Type Coffee Vending Machine	Model 9100 - 95	N° T.I. 03 - 2022					
Serial Number 13521503	Subject OR Material modification of the NTC PROBE	ISSUED FOR (X)	<table border="1"> <tr> <td>Action</td> <td></td> </tr> <tr> <td>Information</td> <td>X</td> </tr> </table>	Action		Information	X
Action							
Information	X

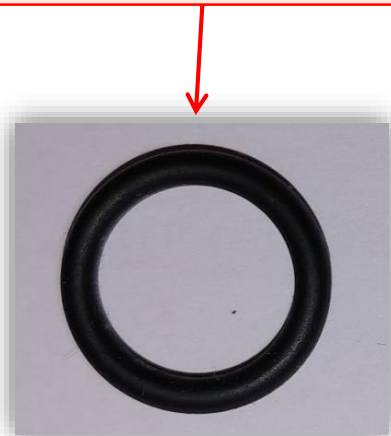
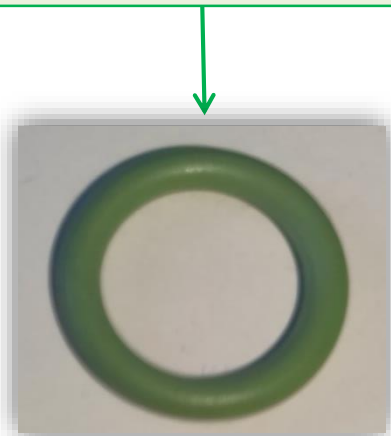
To avoid any hydraulic leakage

The **OR** of the *NTC probe* has been replaced by a **new** one made of **new** material: **FKM** (instead of **EPDM**) that guarantees greater resistance to the working temperatures of the boiler.

New OR gasket - FKM - 1,78X9,25 (green)

Spare code: **11013173**

Pre – modific. OR gasket - EPDM - 1,78X9,25

Spare code: **251556**

The **new OR** can be used on machines previous the S/N above.
